SUBJECT: Amendment to Special Use Permit for a school, originally granted by Ord. 631-23 at 6004 Hill Avenue

The Toledo City Plan Commission recommends approval of SUP25-0039, a request for an amendment to a Special Use Permit for a school, originally granted by Ord. 631-23, to the Toledo City Council, for the following **two (2) reasons**:

**AL MAHDI  
ACADEMY  
K-8 SCHOOL**  
AT THE  
**JAAFARY  
ISLAMIC  
CENTER**  
6004 HILL AVE.  
TOLEDO, OH 43615

# SITE PLAN

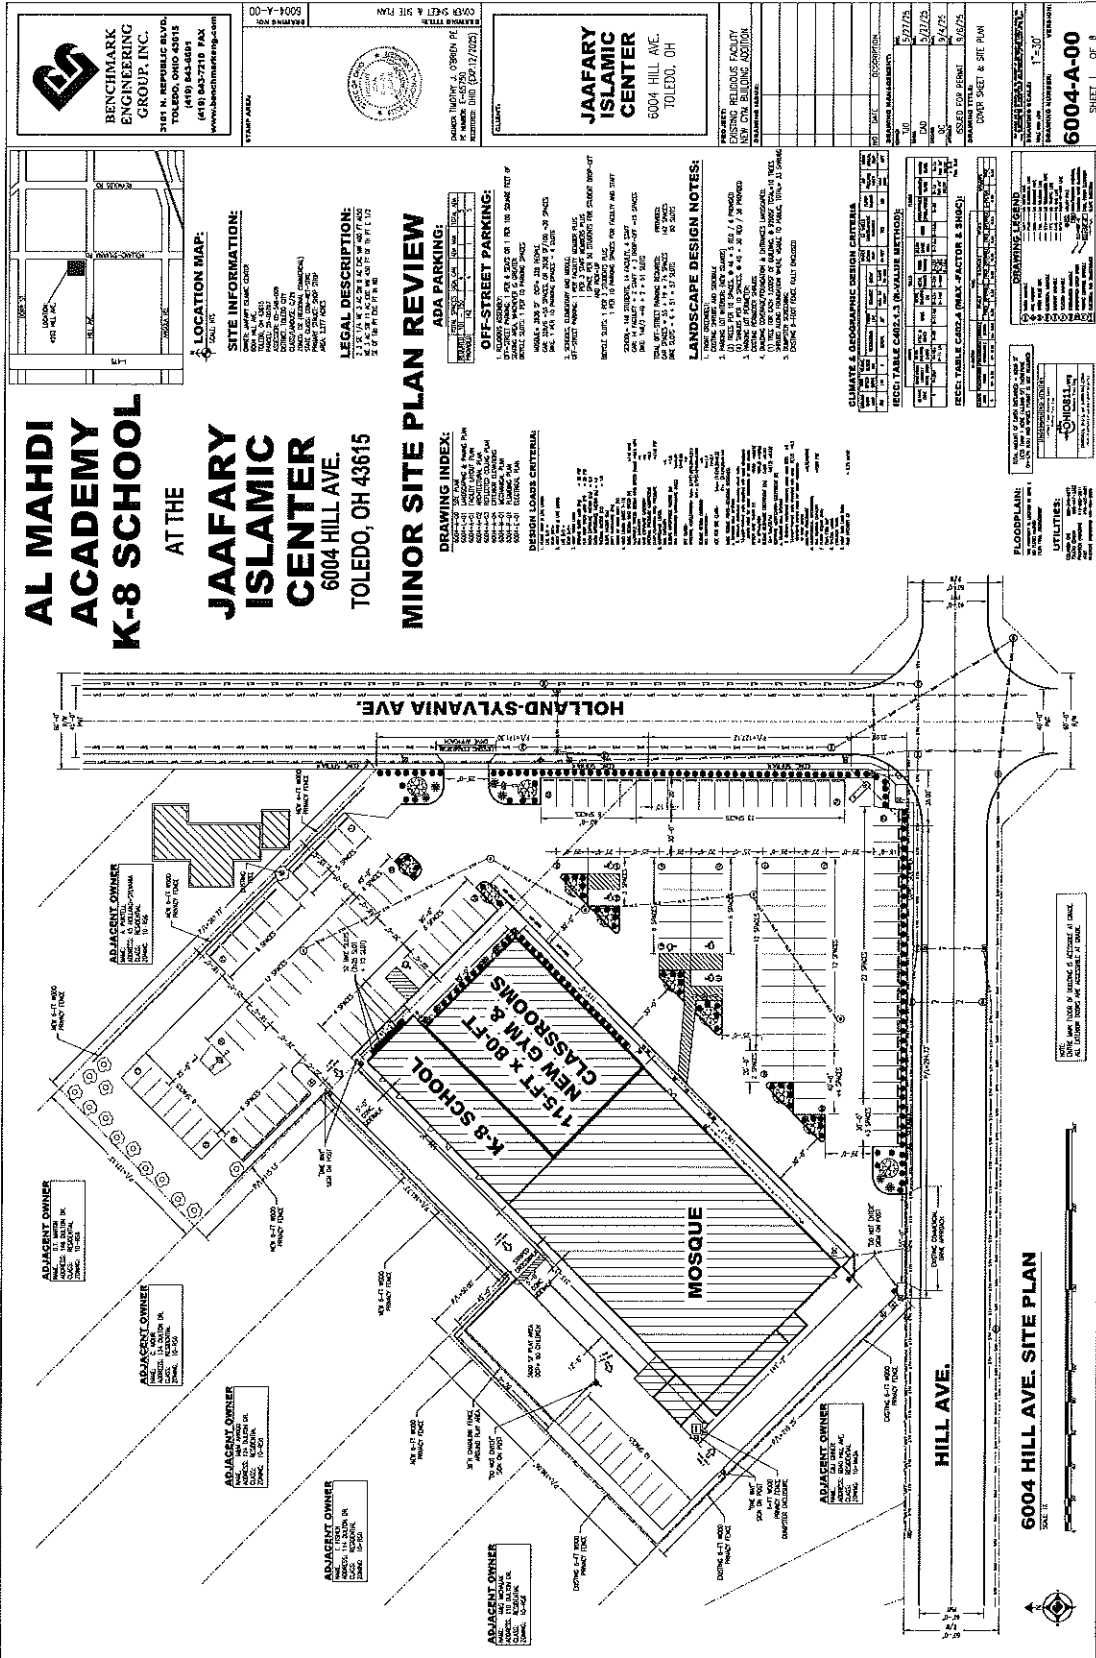
5. Post-construction stormwater management is required for a project of this size; the site plan needs resubmitted. Changes to the site plan made for fulfilling stormwater requirements will necessitate Plan Commission concurrent review and approval. Storm requirements are given in the 2014 Infrastructure Requirements, available online at <https://cdn.toledo.oh.gov/uploads/documents/Transportation/Engineering/2014-Infrastructure-Standards-with-updated-sewer-rates.pdf>

- a. For a partial site redevelopment such as this, the amount of required stormwater improvements is prorated to the amount of redevelopment (the building addition and proposed pavement near the western drive entrance).

- b. Whereas other areas of the site may be most advantageous for fulfilling the requirements, the improvements may manage an equivalent amount of drainage area anywhere on site.

12. A sidewalk connection is required from the sidewalk in the right-of-way to the building sidewalk for pedestrian traffic per TMC 1107.1300.
13. Accessible parking signage must be posted directly in front of the parking space at a height of no less than 60 inches and no more than 72 inches above pavement level per TMC 1107.1704.
14. Wheel stops are required at all parking spots abutting property lines, sidewalks, planting strips and buildings per TMC 1107.1907.

26. Per TMC§1107.0304 one (1) space paved off-street area for dropping off and picking up students at the school must be provided **Acceptable as depicted.**
27. Per TMC§1107.0900, bicycle parking shall be provided, with one (1) bicycle space per three (3) students plus one (1) bicycle spaces per 10 parking spaces for faculty and staff **Acceptable as depicted.**
28. A detailed site, lighting, fencing and four (4) copies of a landscaping plan (separate from building & site plans) shall be submitted to the Plan Director for review and approval. Such plan shall include:
  - a. A five-foot (5') greenbelt is required along the property line fronting Hill Avenue and Holland-Sylvania Road. The frontage greenbelt shall include a solid evergreen hedge to screen parking in the front of the property and prevent headlights from being seen from the right-of-way. **Acceptable as submitted.**
